Re: Professional Engineer's Certification of Permanent Control Measure
Flying Horse North Filing No. 3, Pond A

This letter serves as a Pond Certification for the constructed Full Spectrum Detention Facility "Pond A" located in Flying Horse North Filing No. 3. The permanent control measure is located south of Old Stagecoach Road, east of Allen Ranch Road, and north of Lot 51 within the Flying Horse North subdivision, Filing No. 3, El Paso County, Colorado.

Project: THE CLUBHOUSE AT FLYING HORSE NORTH (AS-BUILT CONDITION POND CERTIFICATION)

Basin ID: PROPOSED POND A MODIFICATIONS

DETENTION BASIN OUTLET STRUCTURE DESIGN

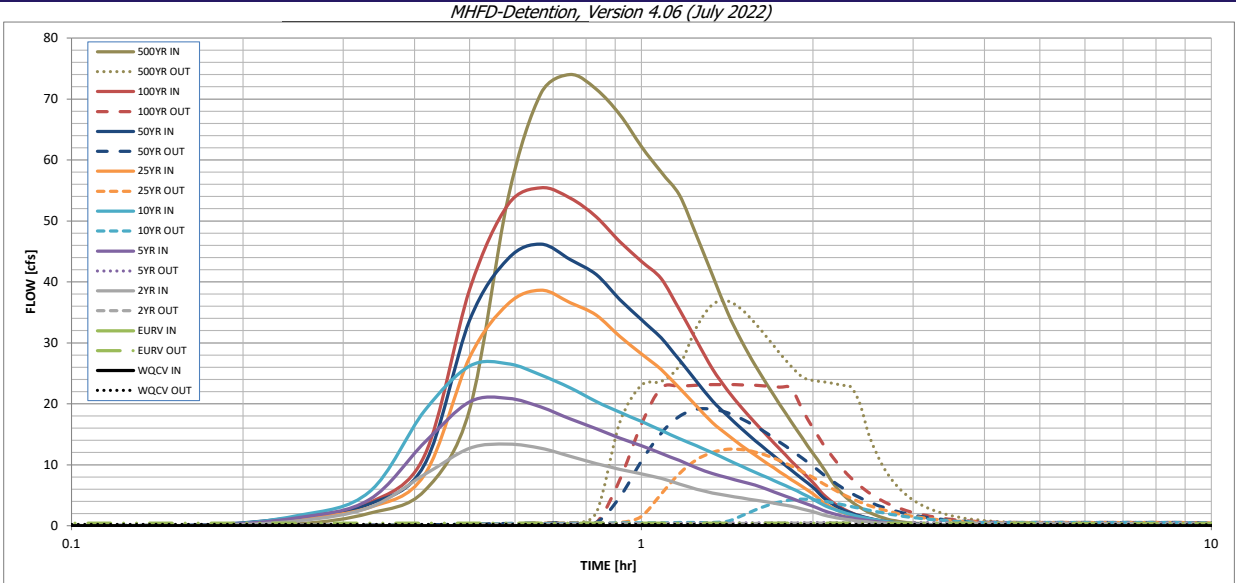
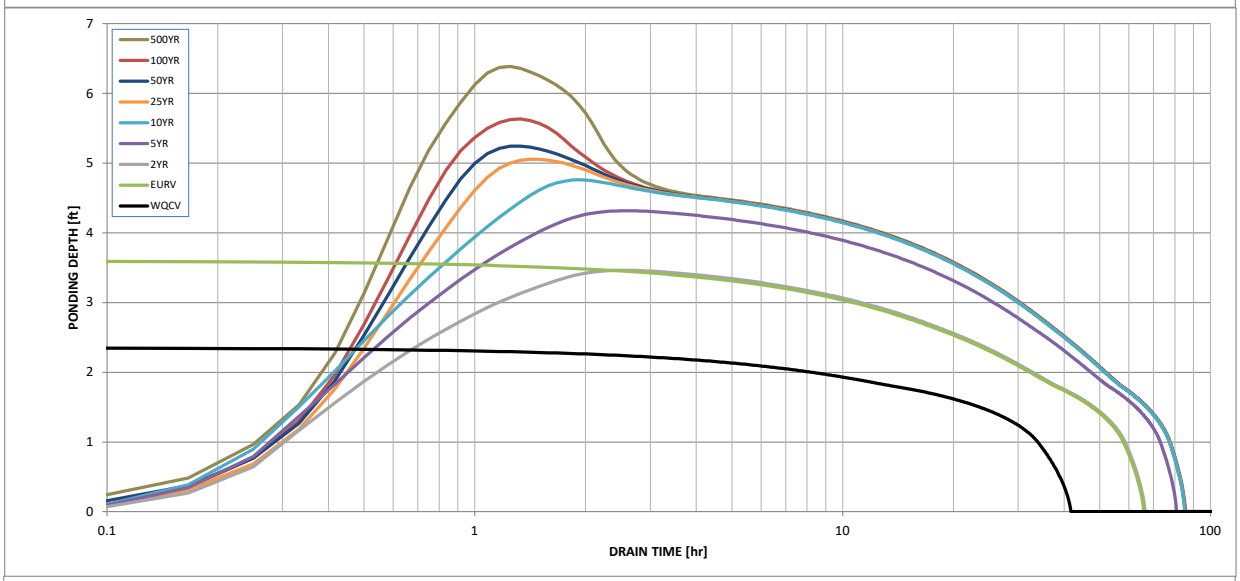
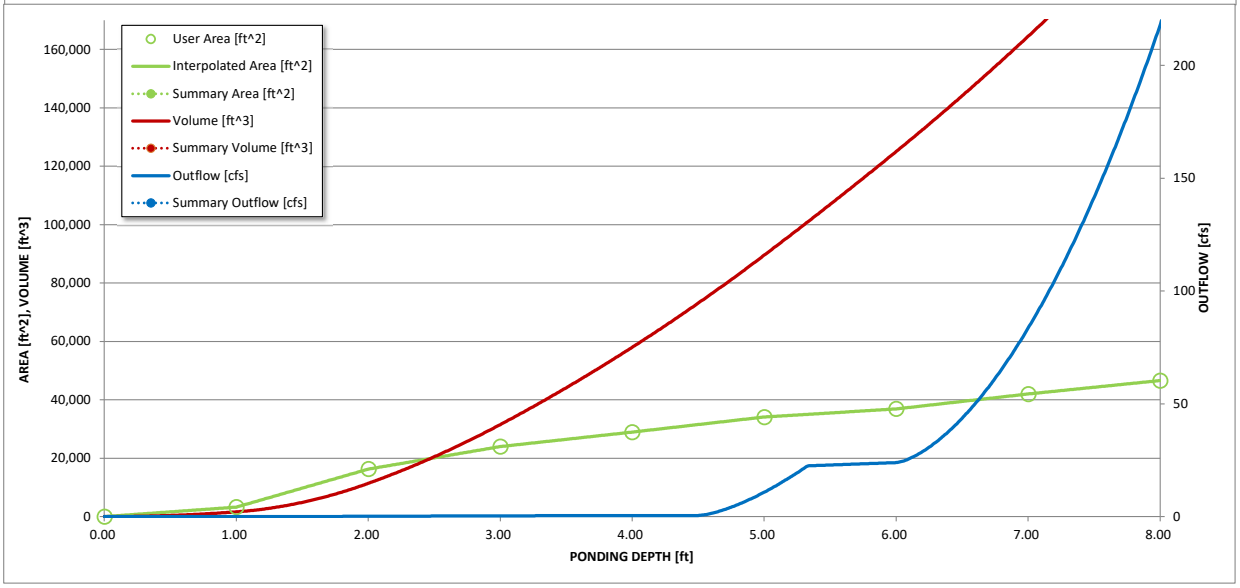
this is the only input cell that is different from the clubhouse design. It was 8ft with the clubhouse design. This also doesn't match the detail in the as-built CDs (Sht 23)
